Bremsbelagsatz / Brake pad set

**Porsche 911 (996/997) – WVA 23139 (T1291) and WVA 23330**

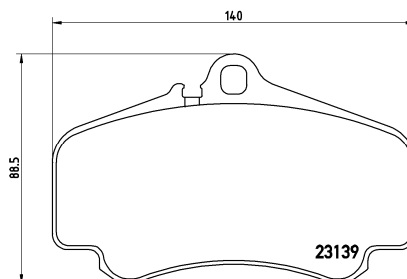
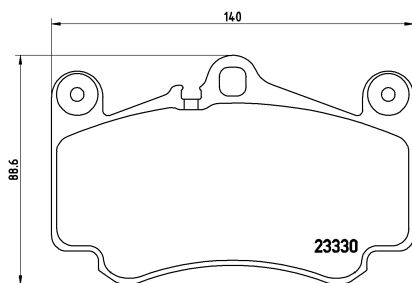
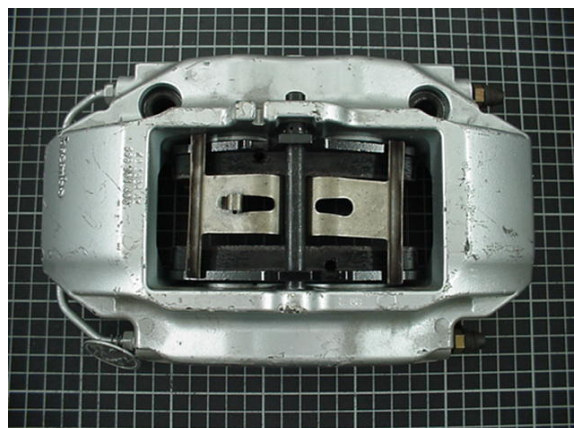
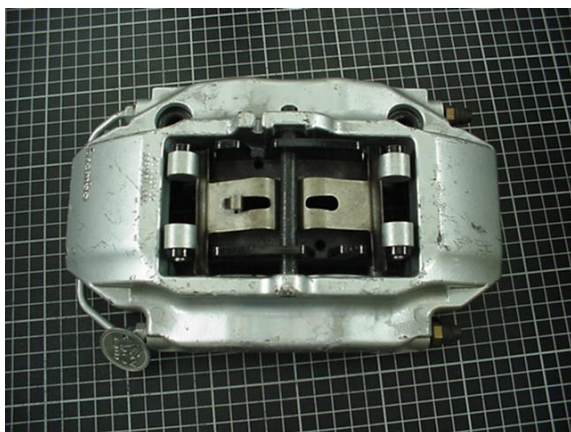
Despite the backing-plate differences between the WVA No. 23330- with additional tilgerweights- and the WVA No. 23139 - without tilgerweights- the fitting is possible with both versions!

Tilgerweights are developed for comfort reasons. Due to the mix characteristic of PAGID reference **T1291 = WVA 23139** there is no need for an introduction of WVA 23330. Furthermore please consider that tilgerweights can even have a negative impact in combination with certain mixes!
